A RADICAL SOFTWARE STATE-OF-THE-ART REPORT

**Tivicon:
MODIFICATION
FOR AVC-3400
VIDEO
CAMERA**

"P" VIDEO PRINTED CIRCUIT BOARD - CONDUCTOR SIDE

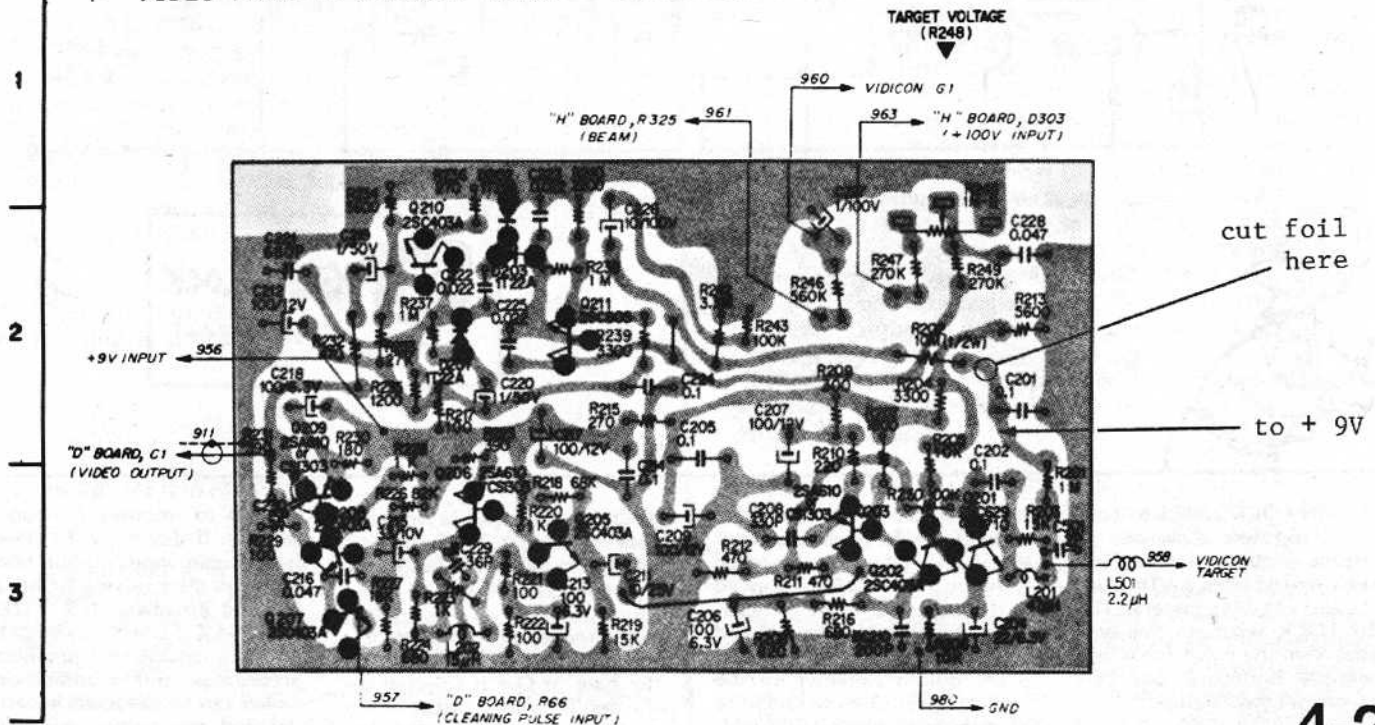
1. Remove "P" Circuit Board behind case as shown on fig. 2-1 (fig. numbers correspond to SONY Service Manual for AVC-3400 camera).
2. Cut foil as indicated fig. 4-2 and schematic fig. 4-5. Connect free end of capacitor C201 0.1MF to + 9 Volt as shown.
3. Re-install "P" Circuit Board behind case.
4. Vidicon position adjustment: move screws to the rear as indicated on fig. 6-5.
